PRODUCT CHANGE NOTIFICATION

Model SRF0703A Series Dual-Winding Shielded Power Inductors

Mounting Base and Shield Design Change

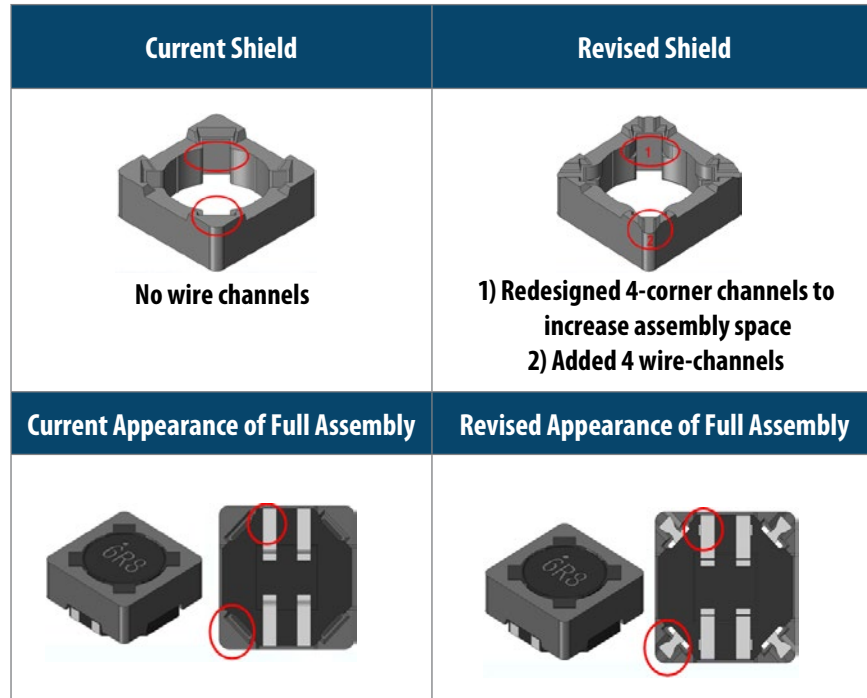
Riverside, California – March 26, 2020 – Effective November 14, 2020, Bourns is changing the Model SRF0703A series inductor mounting base and shield design to address potential wire interference with the terminal pin during assembly. Details of the changes are described below. A list of affected part numbers is available on the following page.

Current Mounting Base	Revised Mounting Base
 <p>Long terminal pin</p>	 <p>Shorter terminal pin</p>
 <p>No terminal anchor</p>	 <p>Terminal anchor embedded in mounting base to increase terminal stability</p>

The form of the inductor will be changed. The fit and function remain unchanged. The reliability and quality of the inductor should be improved from the mounting base and shield redesign. Samples are available upon request.
